VIRM: IN-SERVICE CERTIFICATION AMENDMENT 1 JUNE 2019

List of changes and preview pages (WoF and CoF)

In this amendment

Figure 5-1-4. Windscreen critical vision area (CVA)

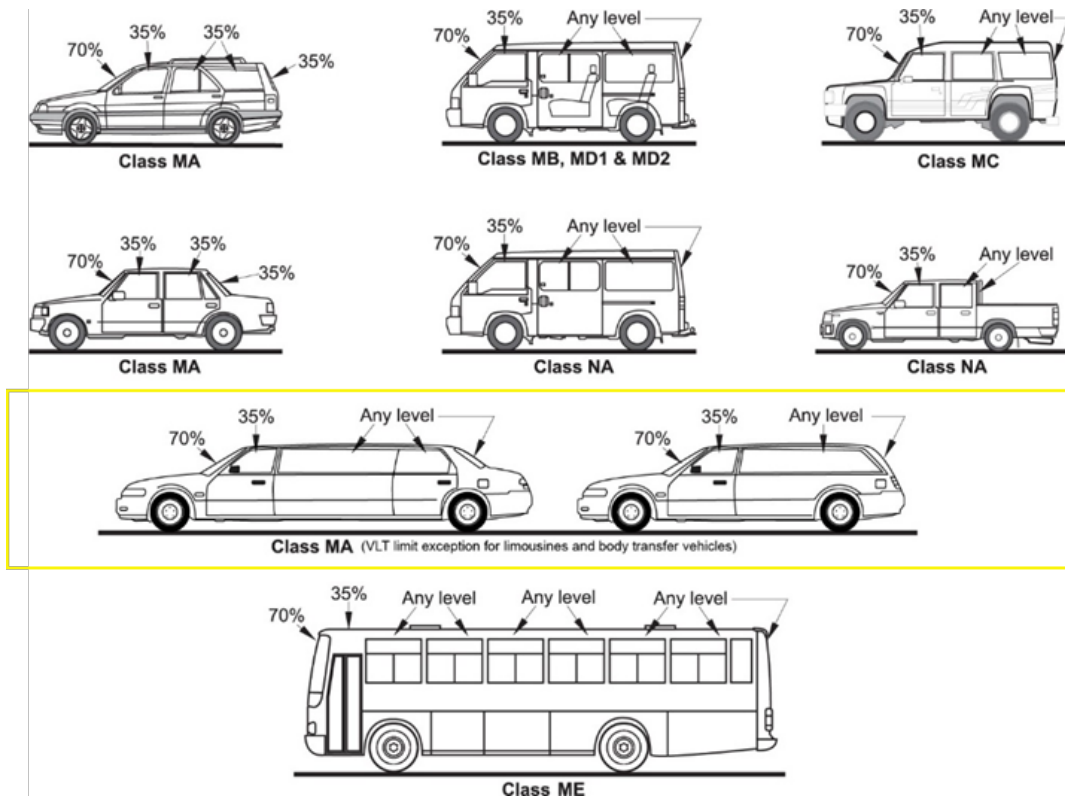
SECTION	CHANGE DESCRIPTION
General vehicles	
4-1 Headlamps	<ul style="list-style-type: none"> • Rfr 15(h) updated to allow for vehicles without a headlamp warning device to be passed if one is not fitted (fitted but not working is still a fail item)
5-1 Glazing	<ul style="list-style-type: none"> • Limousine and body recovery vehicles (hearse) added to figure 5-1-6 Minimum VLT limits for modified glazing (tinted overlays) for different vehicle classes • Critical vision area diagram updated to align with AS/NZS 2080-2006 • Late addition: Table 5-1-6. Permitted modifications <ul style="list-style-type: none"> ○ New row - 'Window port or hatches' in 'Front side window' section relating to class ME vehicles
Heavy vehicles	
4-1 Headlamps	<ul style="list-style-type: none"> • See general vehicles
5-1 Glazing	<ul style="list-style-type: none"> • Critical vision area diagram added
7-1 Seats and seat anchorages	<ul style="list-style-type: none"> • Note added about modification or repair before April 2002

To be measured from the inside of the vehicle from the point where the glass is visible (ie after any seals)

Figure 3-1-3. Drawbar attachment to trailer

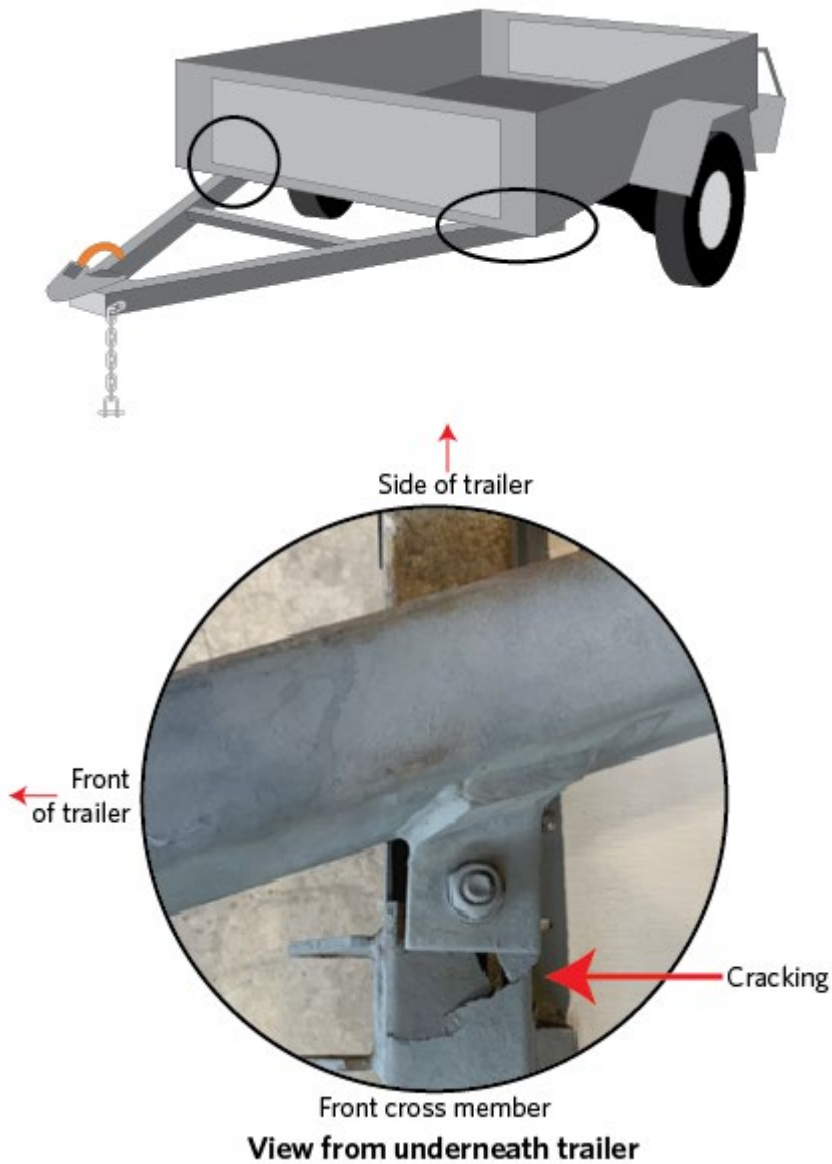
3-1 Structure	<ul style="list-style-type: none"> Note and image added to assist vehicle inspectors with spotting cracking failure at the point(s) where the drawbar attaches to the body of the trailer in light trailers Repaired Trailpro trailers can be identified by the 'R' after the serial number on the plate Image of a repaired Trailpro trailer
---------------	--

Special attention should be given to the point or points where the drawbar attaches to the body of the trailer. This is often the first point of structural failure on trailers.

- a) deformation from the original shape that has affected the vehicle's structural integrity (**Note 2**), or
- b) cracking (**Note 3**) (**Figure 3-1-3**), or
- c) fracture, or
- d) corrosion damage (**Note 1**) that is individually larger than 50mm in diameter (**Figure 3-1-1**), or
- e) any corrosion that the inspector considers has caused weakening of the load-bearing structure, or
- f) poor repairs (**Note 1**) that have not returned the structure to within a safe tolerance of when it was manufactured (**Note 2**), such as:
 - i. filler has been used in an attempt to conceal corrosion damage or deformation of a component, or
 - ii. a high strength steel component has been heated.
